Authorization Basis Change Notice

ABCN Number ABCN-24590-01-00008 Revision 0

ABCN Title Integrated Safety Management Plan (ISMP) Standards Approval Package (SAP) Submittal

ATTACHMENT 1 - PROPOSED PAGE CHANGES TO BFNL-5193-ISP-01, River Protection Project Waste Treatment Plant Integrated Safety Management Plan

Figure 1-1 Project Safety Approach

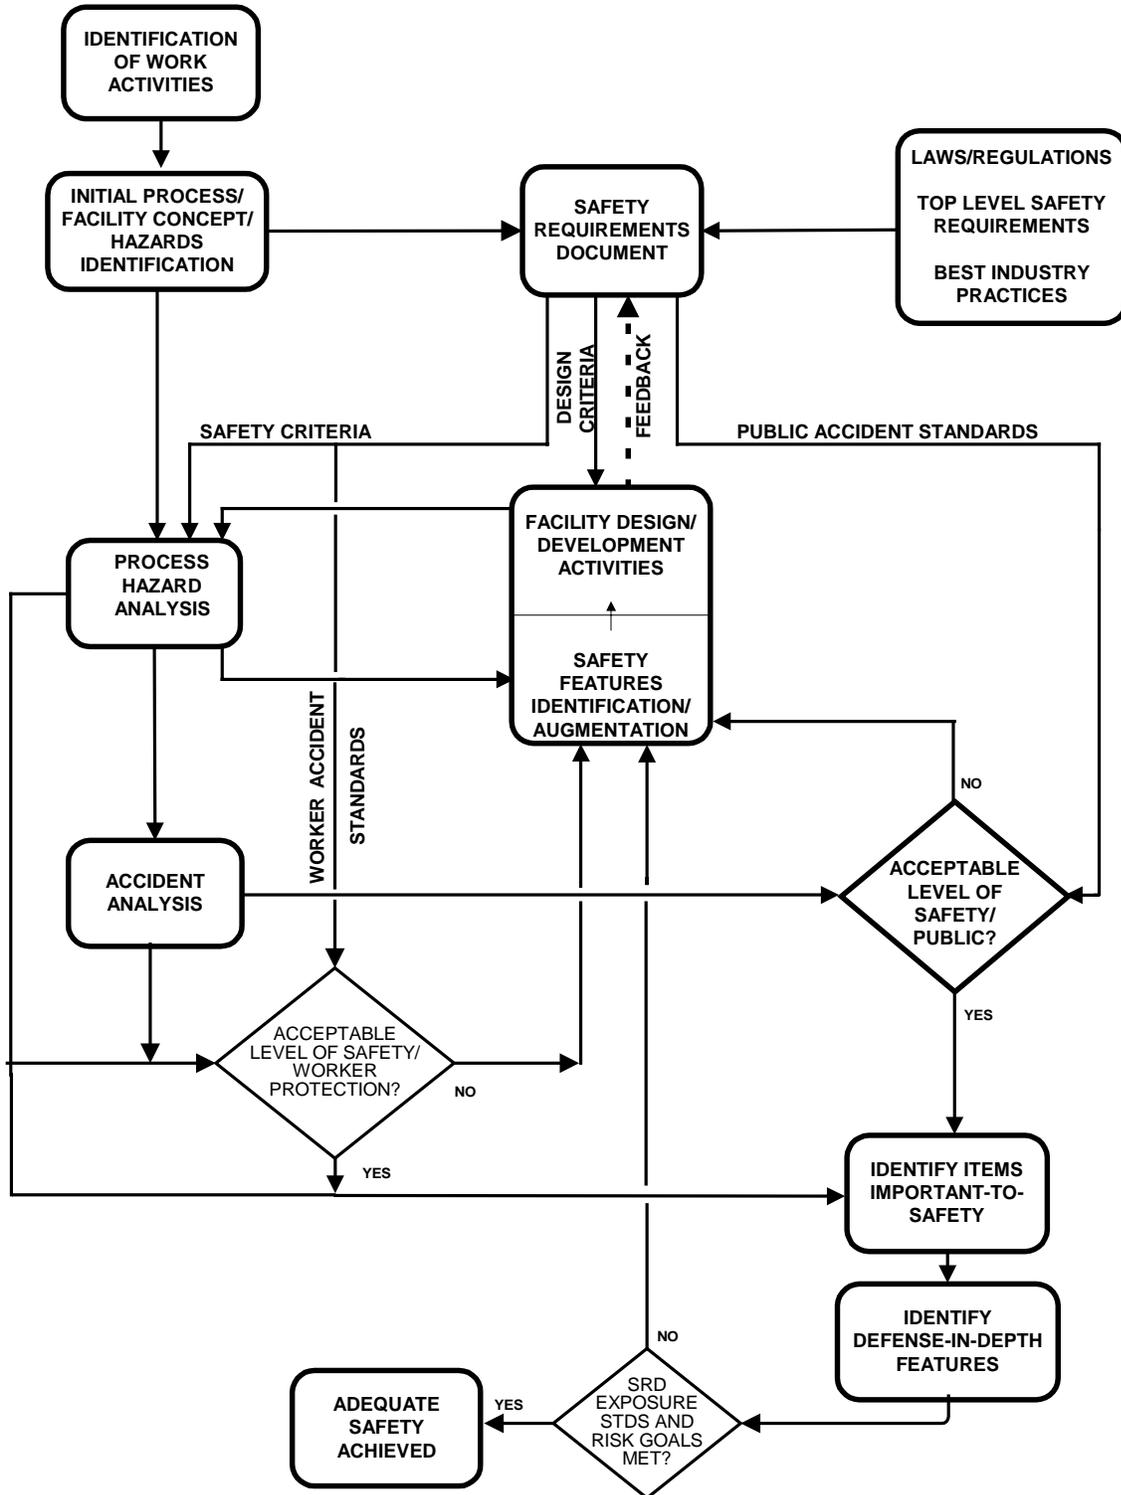
1.2 Figure 1-1 [1-5]	Revise center bottom diamond text to read “SRD EXPOSURE. STDS AND RISK GOALS MET?”	Clarifies that both SRD exposure standards and risk goals being met are used to assess whether adequate safety is achieved.	No	Clarification update; no reduction of prior ISMP commitments or impact on safety basis for the WTP.

Figure 4-1 Safety Management Processes

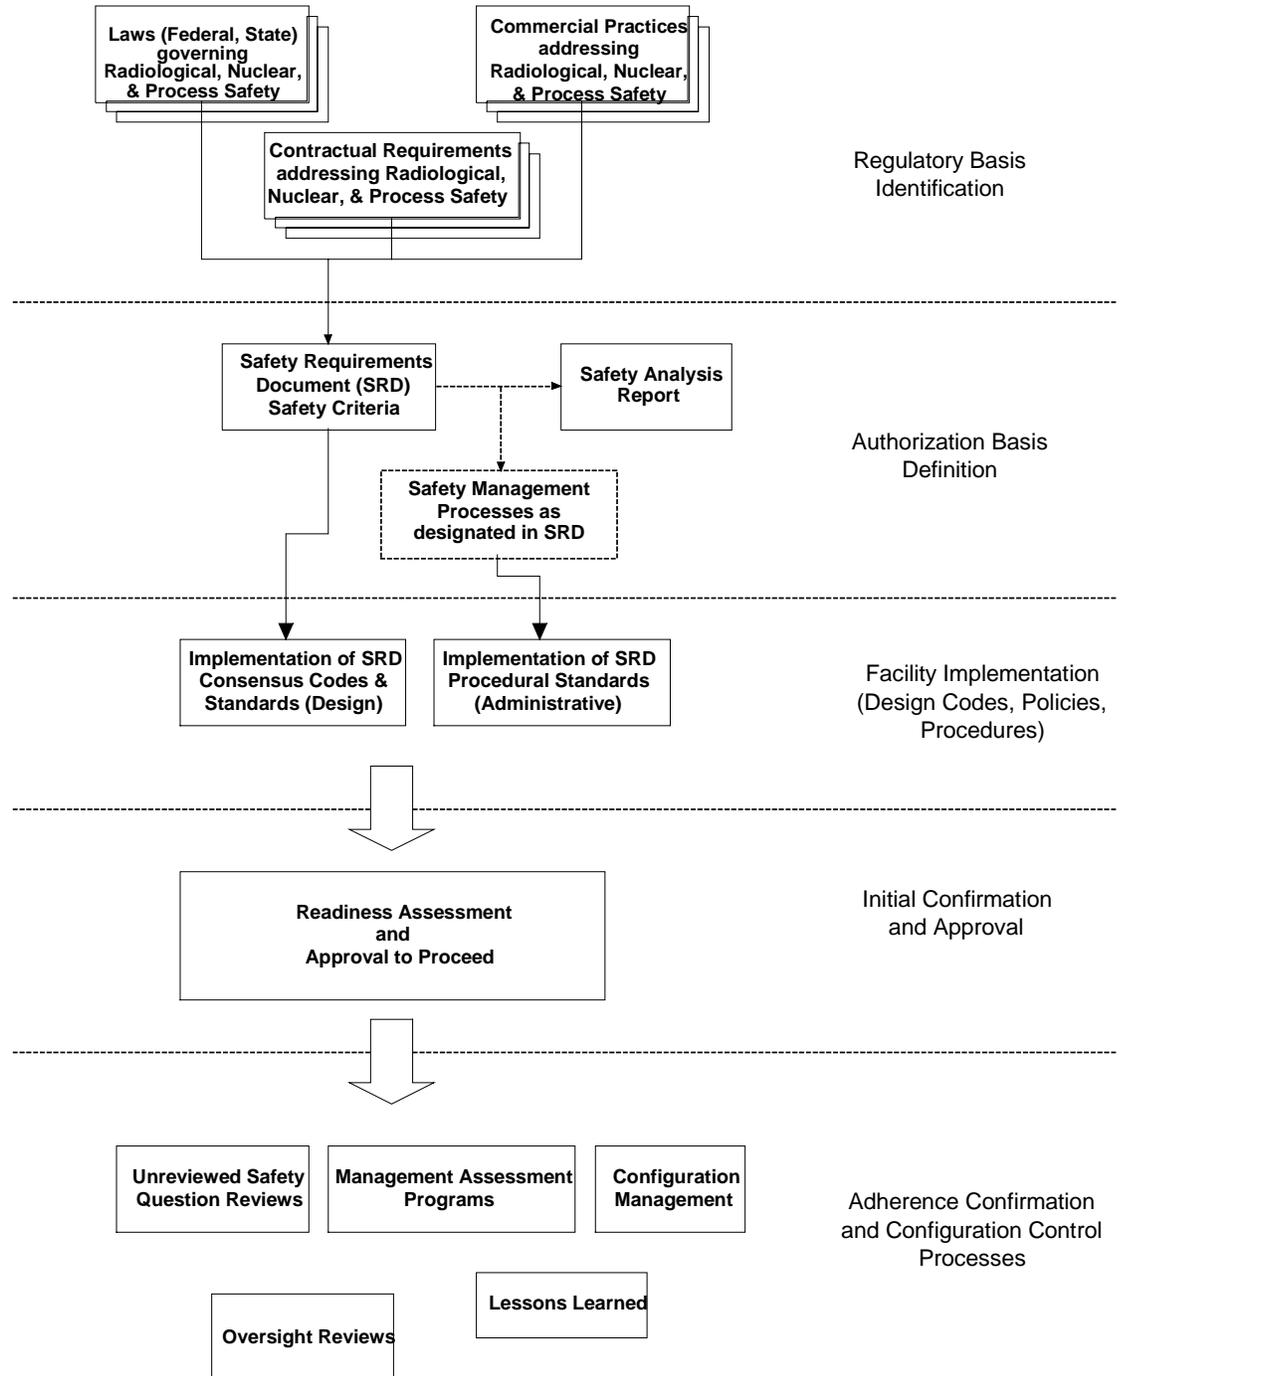
4.1.1 Figure 4-1 [4-2]	In Figure 4-1, update row identifications from “Regulatory Basis” to “Regulatory Basis Identification” and from “Authorization Basis” to Authorization Basis Definition”. Move “SRD” in Facility Implementation row boxes to after ‘Implementation of’ Replace “Operational Readiness Review” with “Readiness Assessment” in Initial Confirmation and Approval row.	Better defines these safety management processes. Clarifies that this implementation is based on SRD requirements, but is not done by implementation of the entire SRD. Clarifies that confirmation & approval is by the more generic term ‘readiness assessment’ that can include ORRs and other methods.	No	Clarification update; no reduction of prior ISMP commitments or impact on safety basis for the WTP.

Figure 4-2 SRD Link to Design

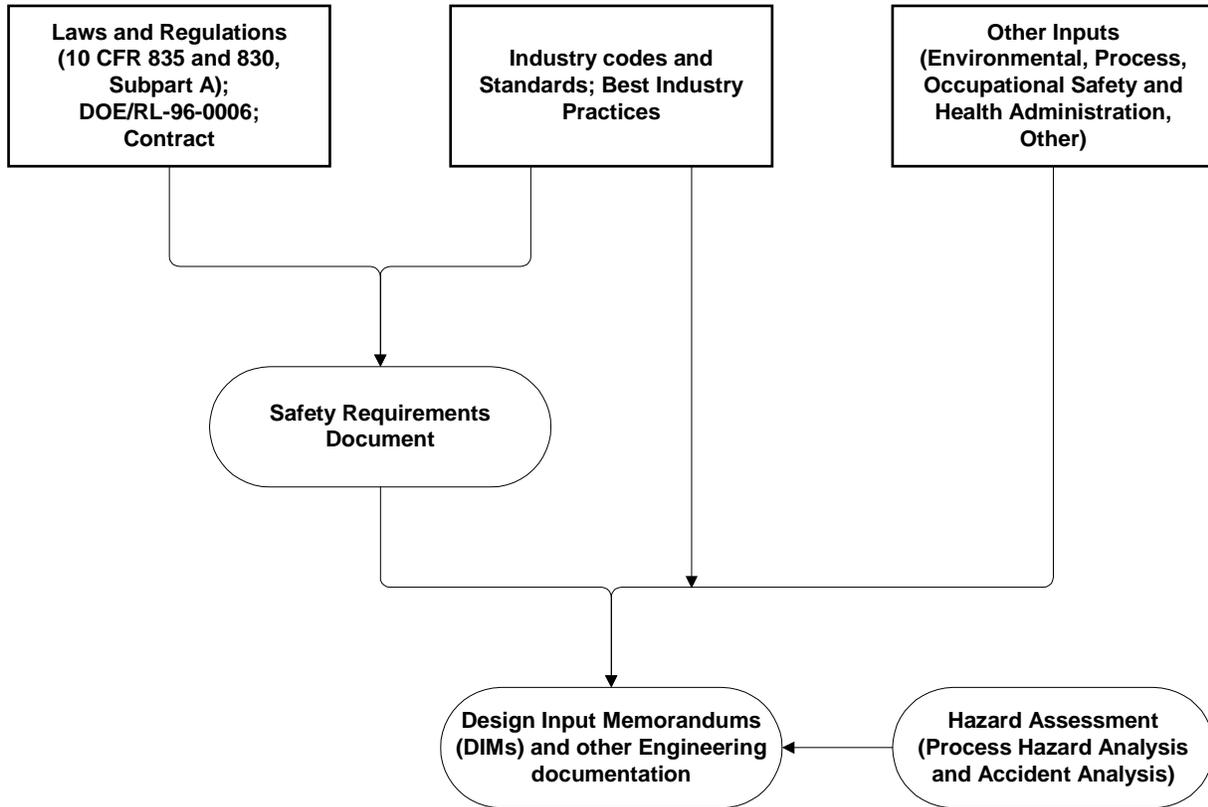
4.1.3 Development of Safety Management Program Figure 4-2 [4-6]	In first row of figure, left box, change “830.120” to “830 Subpart A”; in right box, delete “Quality Assurance”. Change “Design Guides” to “Design Input Memorandums (DIMs) and Other Engineering Documentation” in next to last row on figure. Connect downward line from top entries into the “Hazard Assessment” box. Delete the bottom box on “Engineering Documents”.	Clarifies the Subpart A supersedes 830.120; removes the redundant QA entry, specifies the actual engineering documentation link to the SRD, and shows flow of requirements into the hazards assessments as well as this link.	No	Clarification update; no reduction of prior ISMP commitments or impact on safety basis for the WTP.

Figure 11-1 Management Structure and Organization for the BNI Design, Construction, and Commissioning Contract

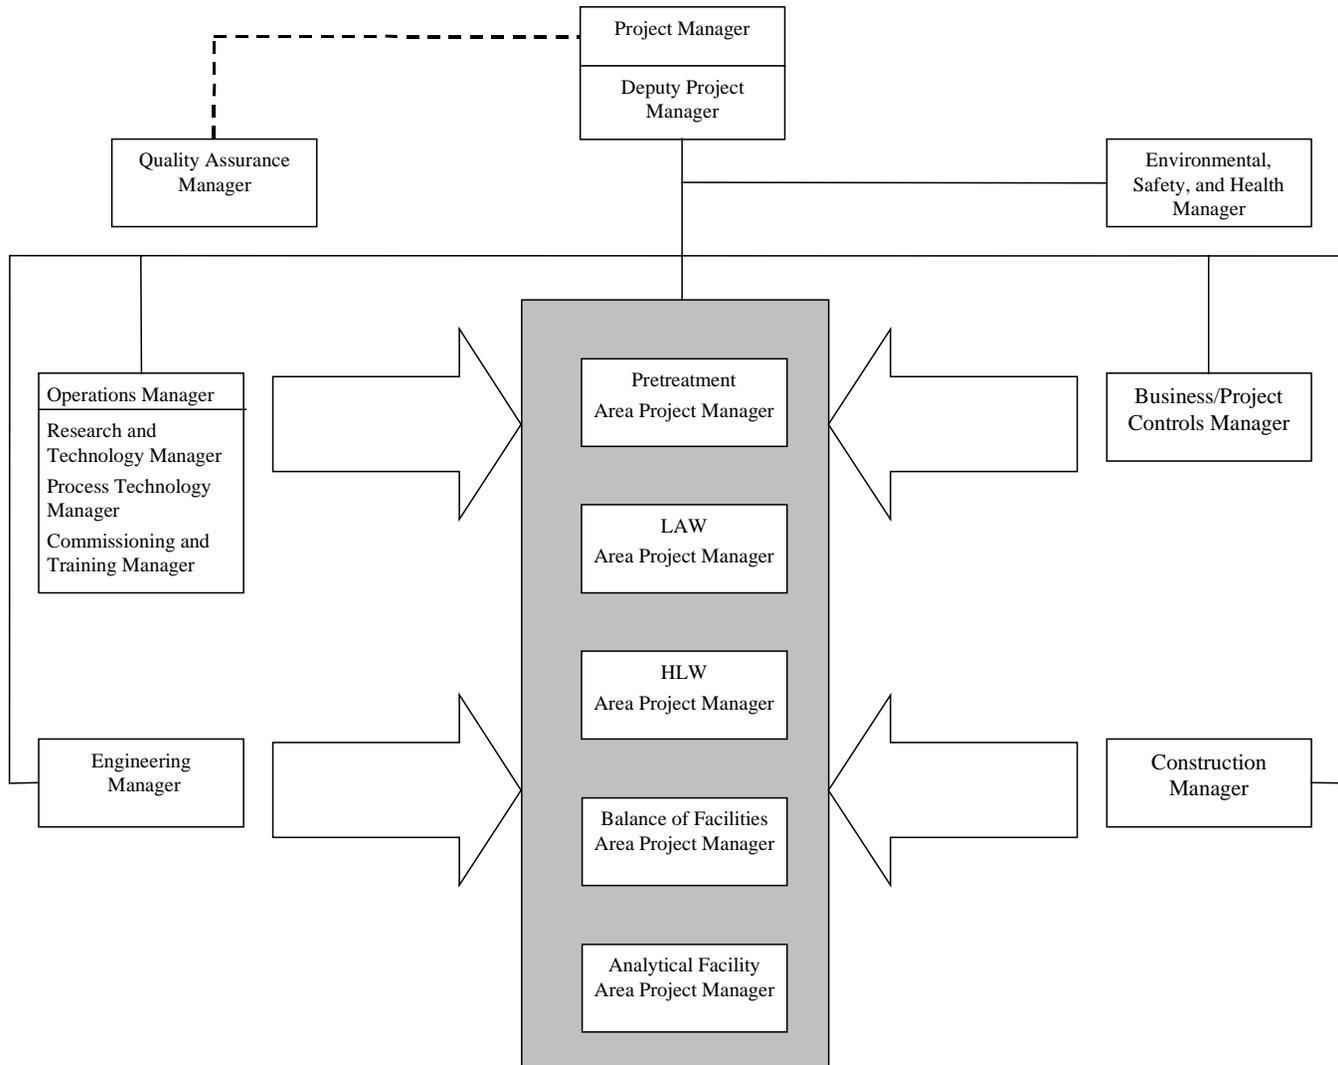
11.1 Design, Construction, and Commissioning Contractor Organization Roles, Responsibilities, and Authorities [11-3]	In Figure 11-1 , add box for “Analytical Facility Area Project Manager” and add Process Technology Manager, Research and Technology Manager, and Commissioning and Training Manager under the Operations Manager. Reverse locations of “Construction Manager” and “Engineering Manager” boxes.	Reflects updated, current Project management structure. Reversing box locations make this figure consistent with the comparable figure in the QAM.	No	Clarification update; no reduction of prior ISMP commitments.
